Architect's Supplemental Instructions

PROJECT:
Summit Square
Apartments Phase II
 837 NW Donovan Road
 Lee's Summit, MO 64086

ARCHITECT'S SUPPLEMENTAL
INSTRUCTION NO.: 16

At the Owner's request, an addition to serve as the Parcel Storage room was added to Building 1. Additional revisions and clarifications to the scope are summarized per sheet, and reason for the change where applicable:

2 ELEVATOR SECTION BLDG C
SCALE: 1/4" = 1'-0"

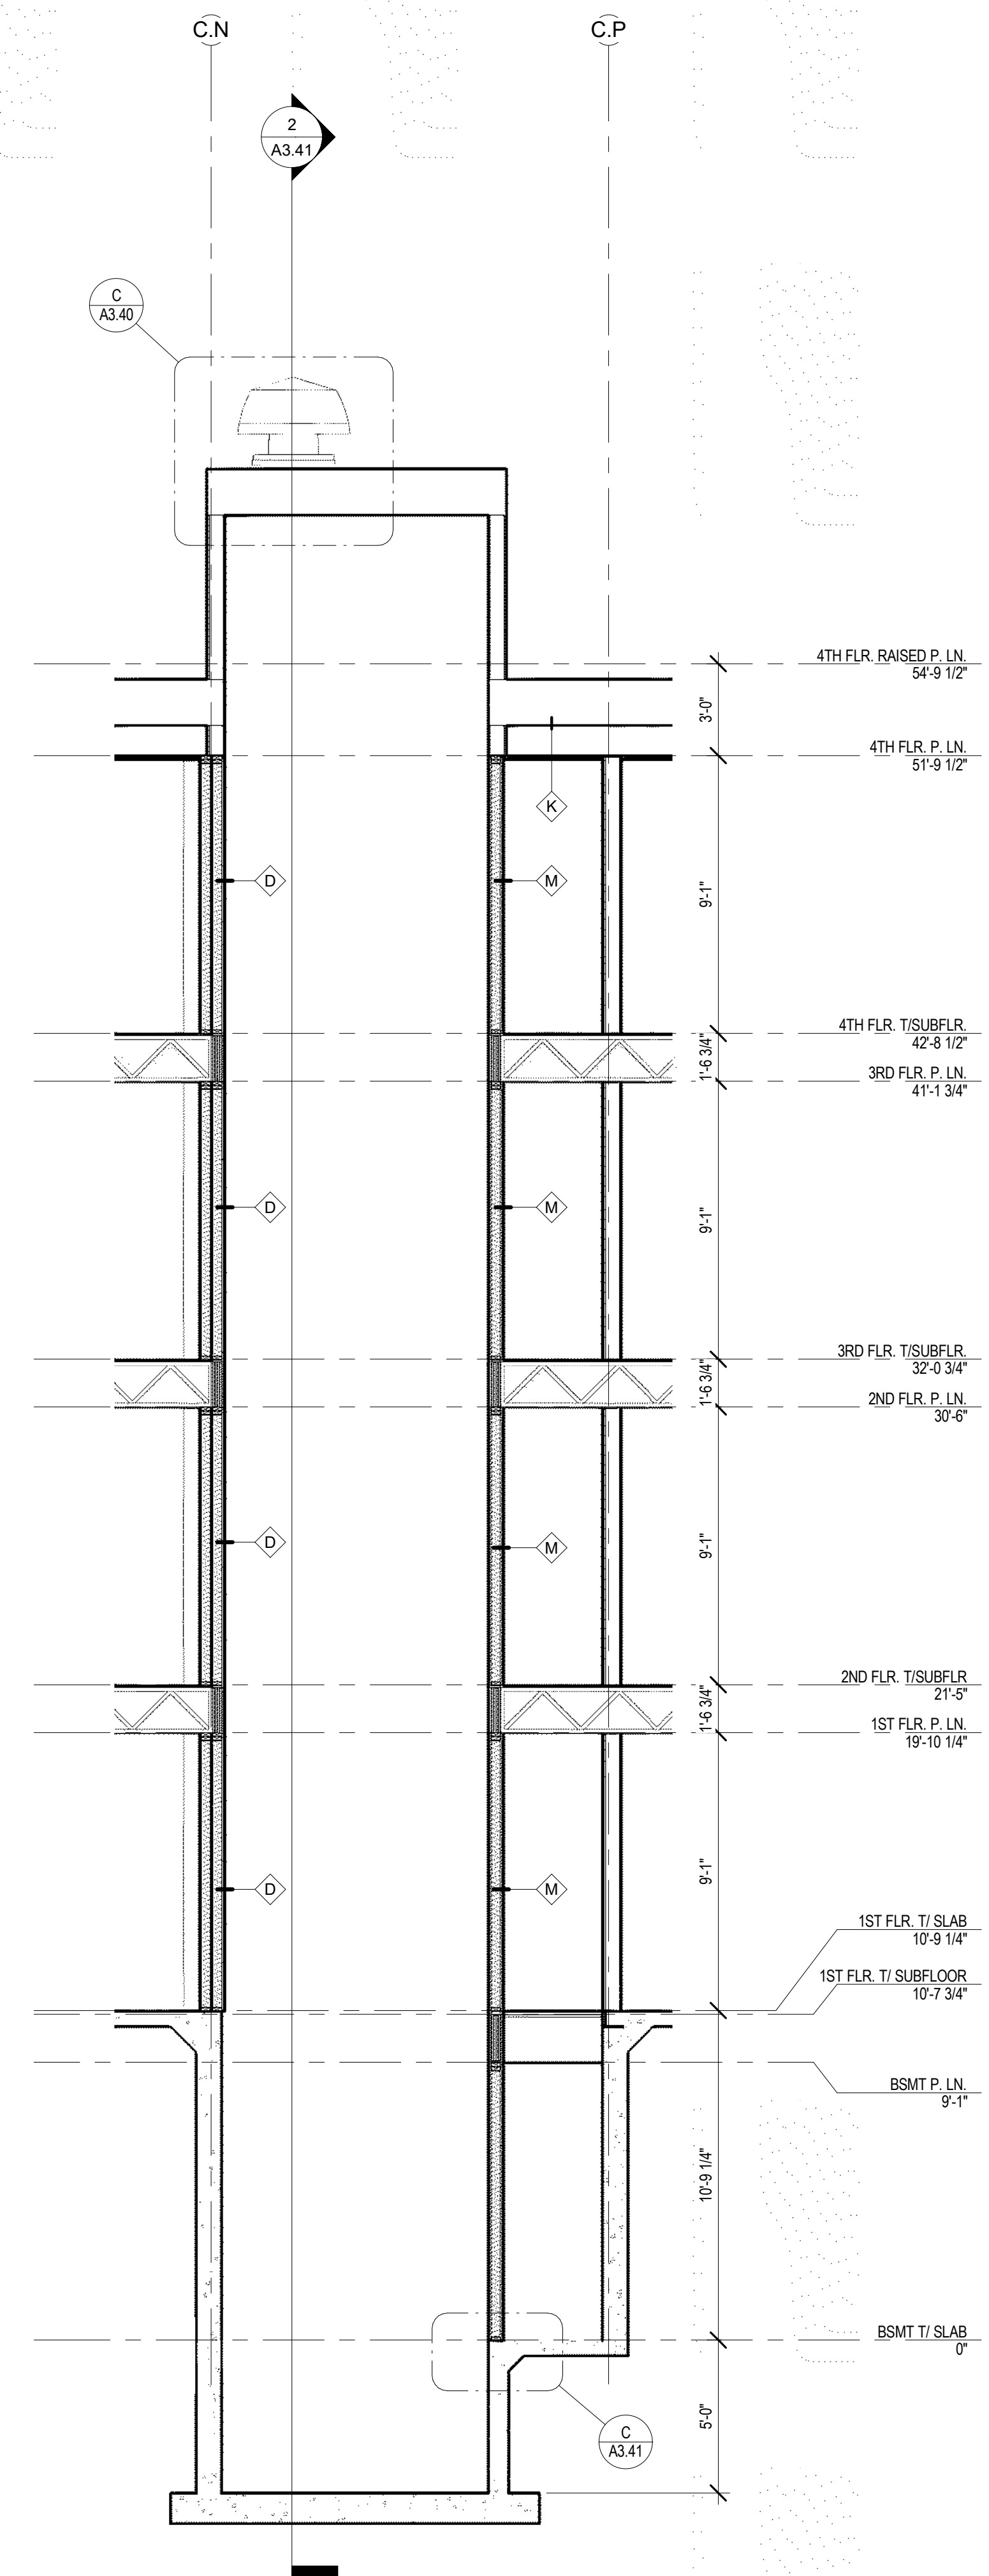
- A2.15B *Revised Elevation for Parcel Storage room addition*
- A3.40 *Document Elevator Beam Height change (as indicated on Elevator Shop Dwgs)*
- A3.41 *Document Elevator Beam Height change (as indicated on Elevator Shop Dwgs)*

A3.42

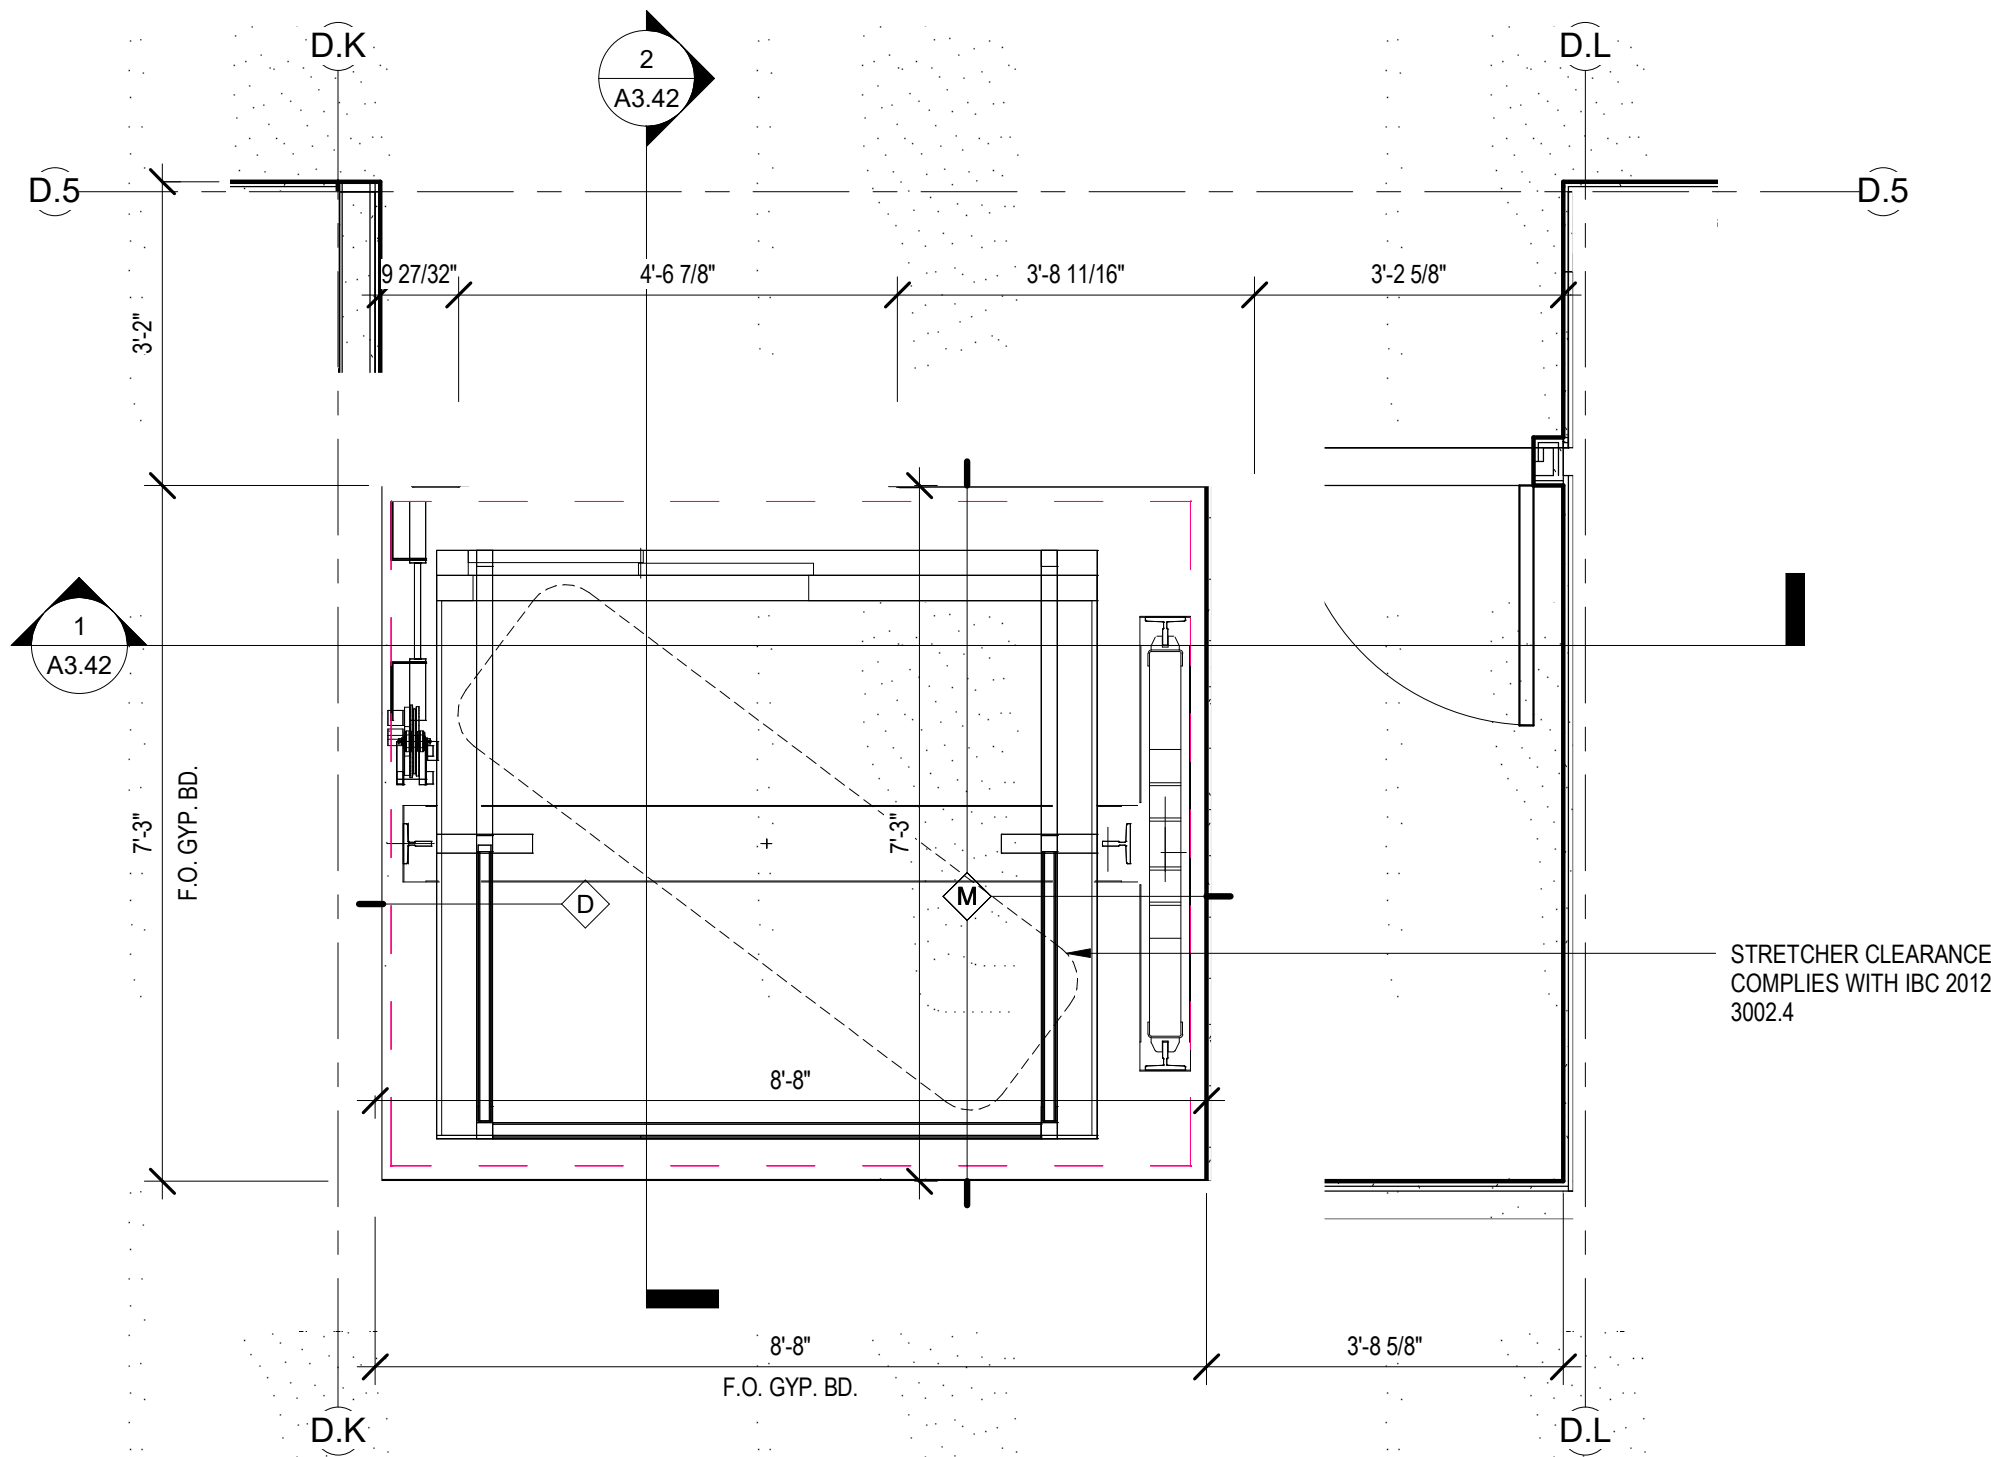
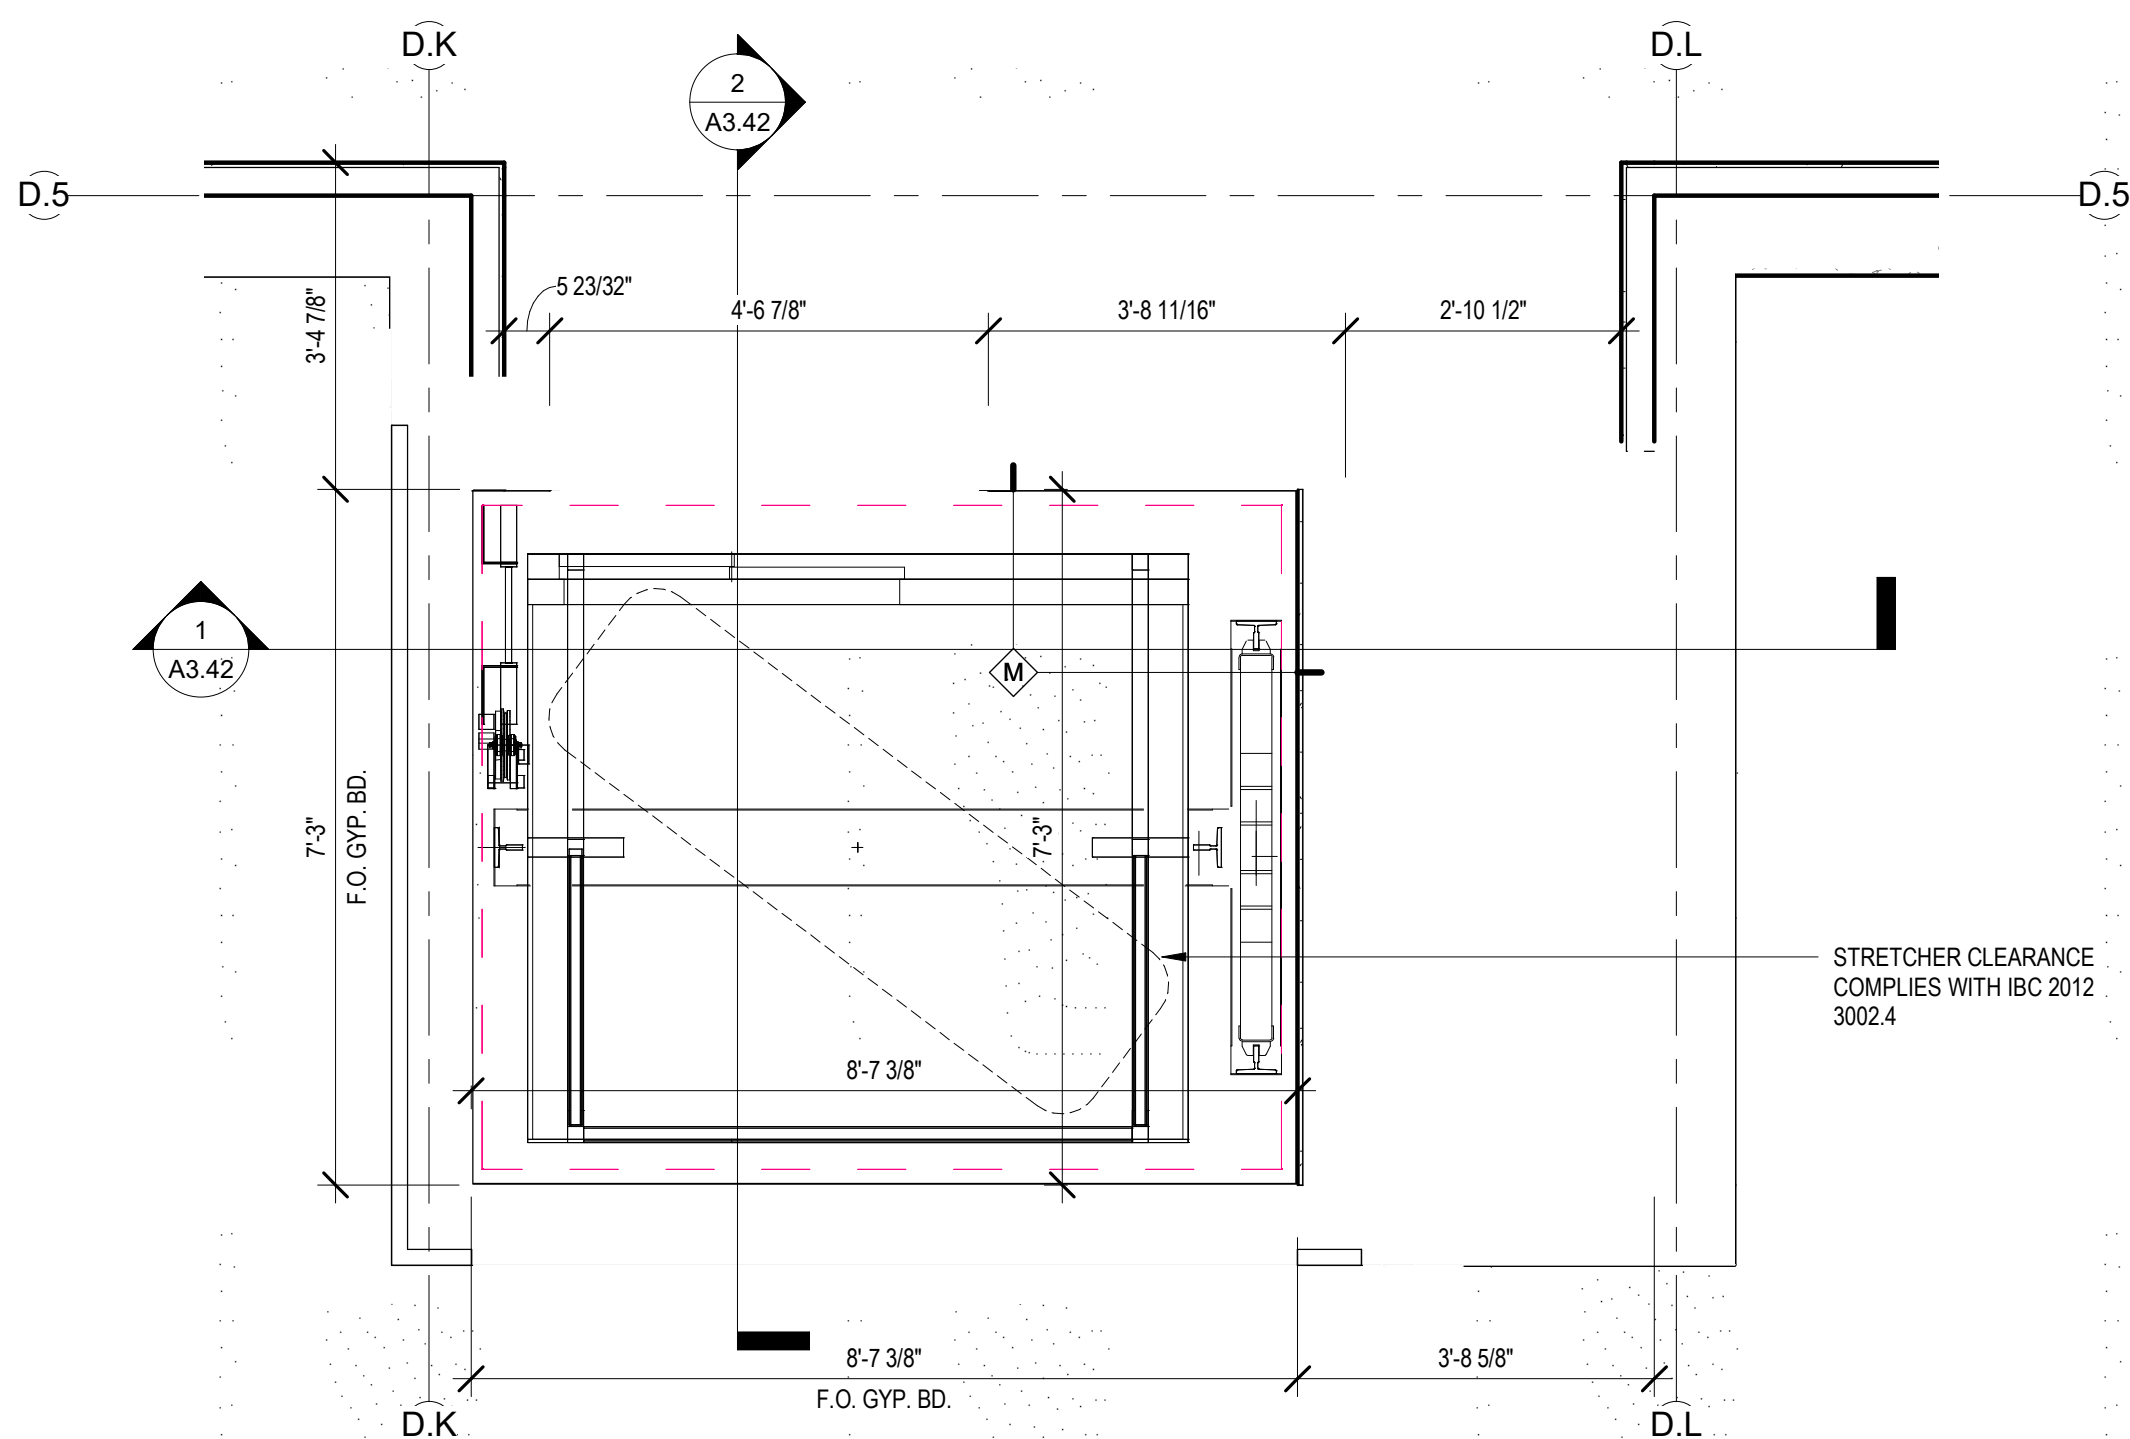
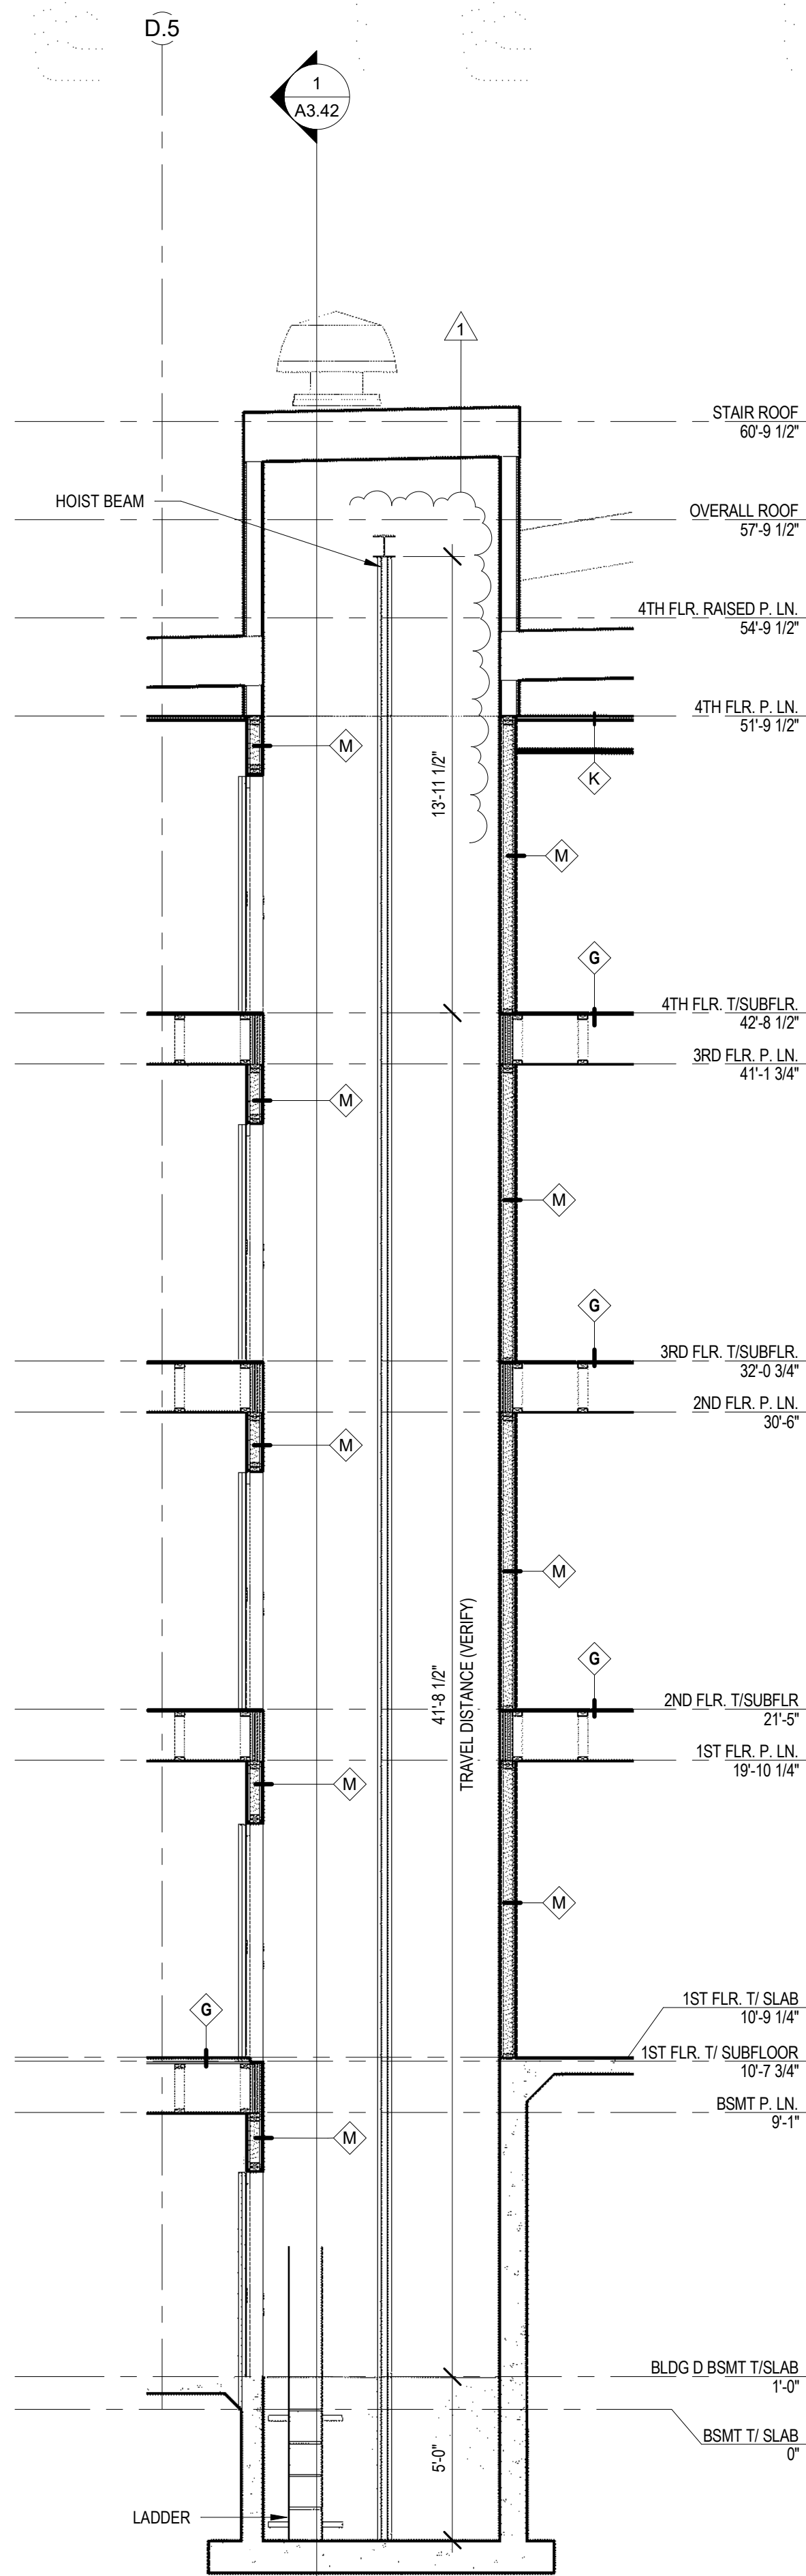
- A3.42 *Document Elevator Beam Height change (as indicated on Elevator Shop Dwgs)*
- A7.00 *Addition of Parcel Storage room, Removal of Yoga Storage Room and associated changes*
